RFT 26-083 Interior Renovations & Air Conditioner Upgrades at Frontenac PS

The following, issued by the Halton District School Board (HDSB) June 18, 2026, shall be incorporated in the specifications and shall form part of the proposal document for the above.

TENDER ADDENDUM NO. 1
2026.06.17

Interior Renovations and Air Conditioner Upgrades at Frontenac Public School
Halton District School Board RFT 26-083
5140 Pinedale Avenue, Burlington, Ontario

Drawing No.:
E3.3

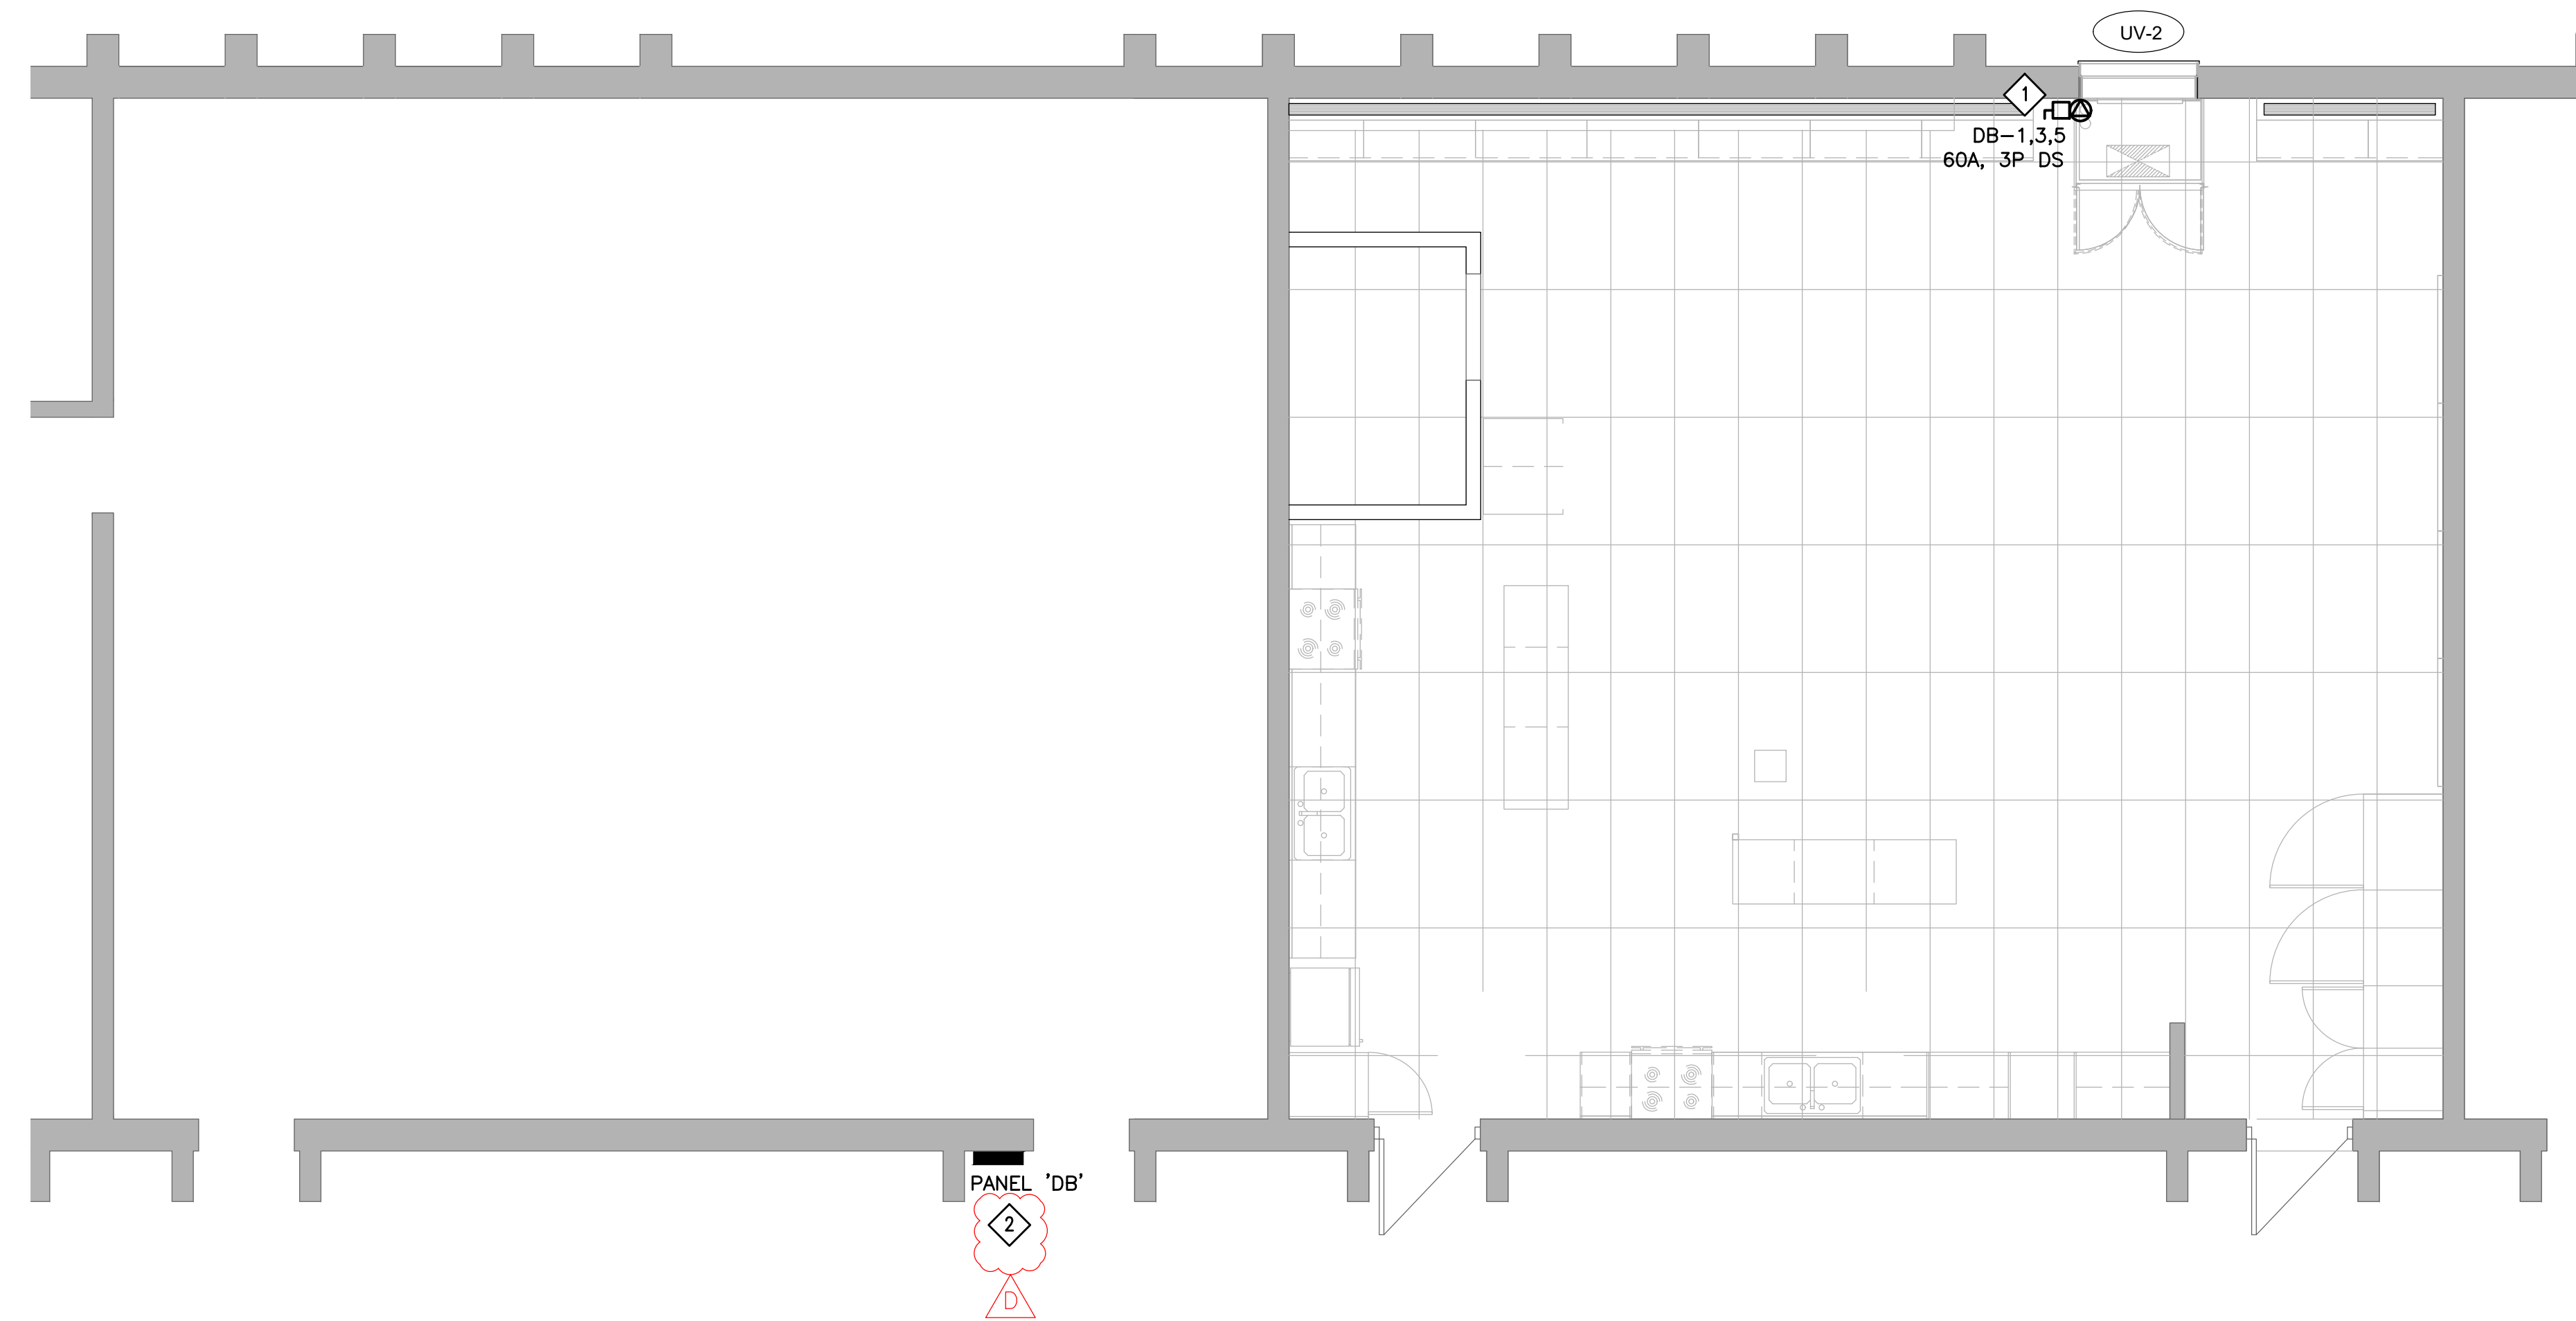
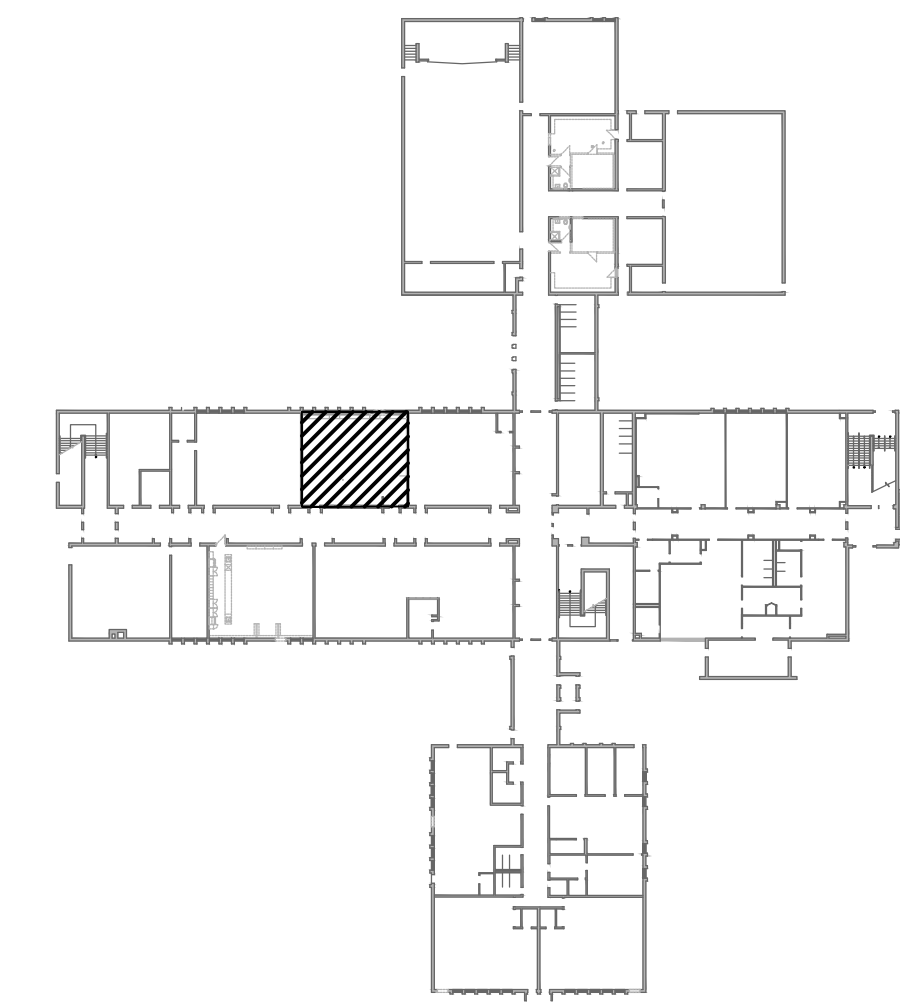
- 1.7 Refer to revised Electrical Drawing 3.3 Rev.D
 - Added drawing keynote 2.

Drawing No.:
E3.5

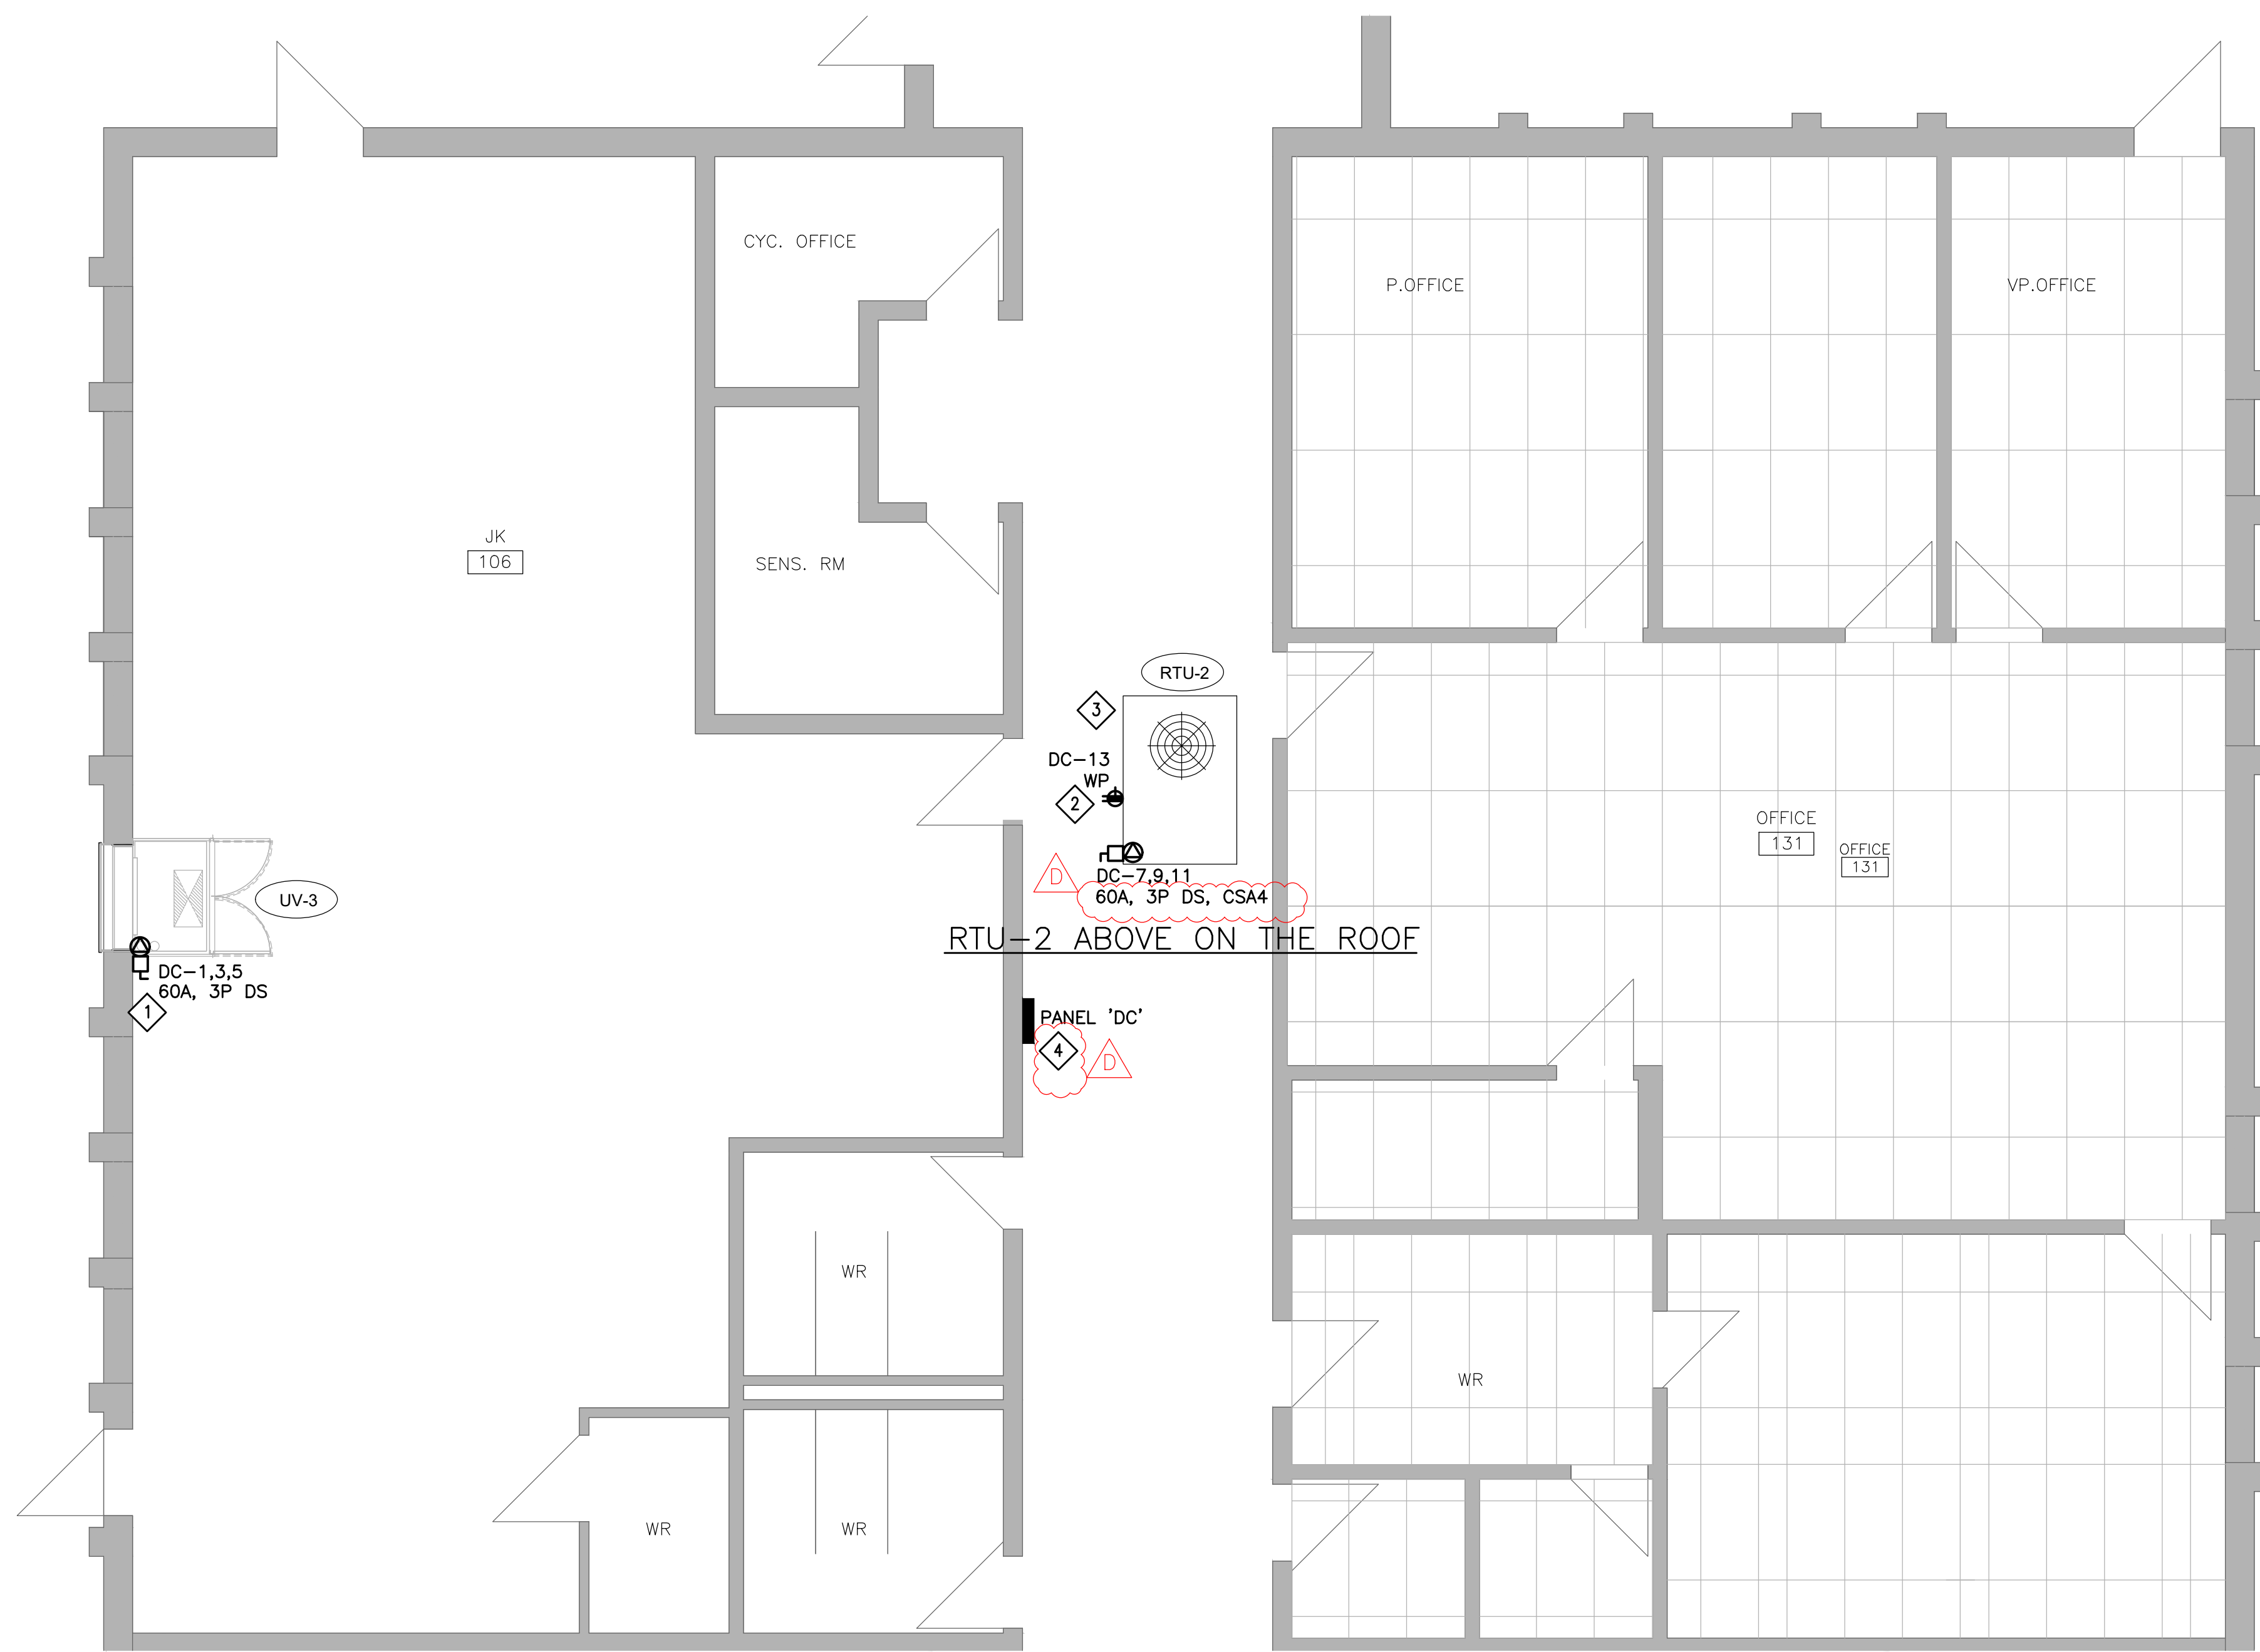
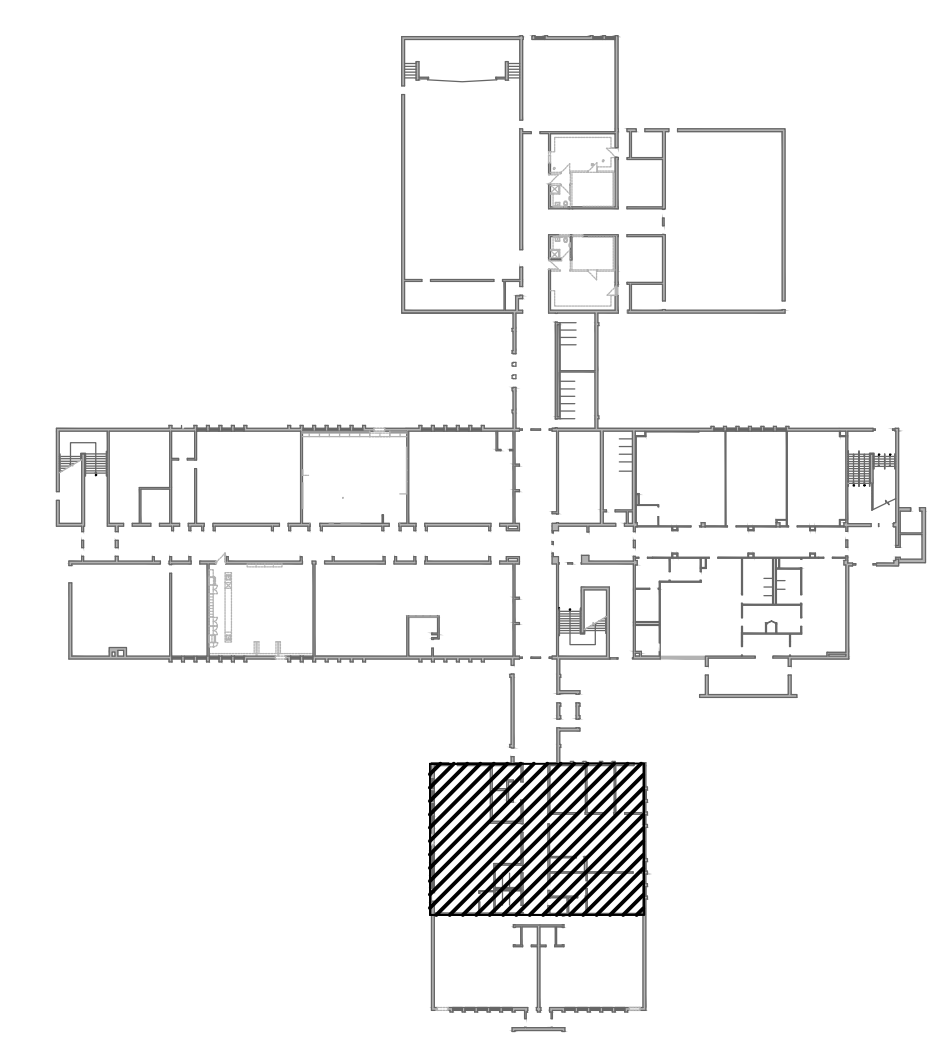
1.9 Refer to revised Electrical Drawing 3.5 Rev.D

- Added drawing keynote 4.
- Revised a disconnect switch details.
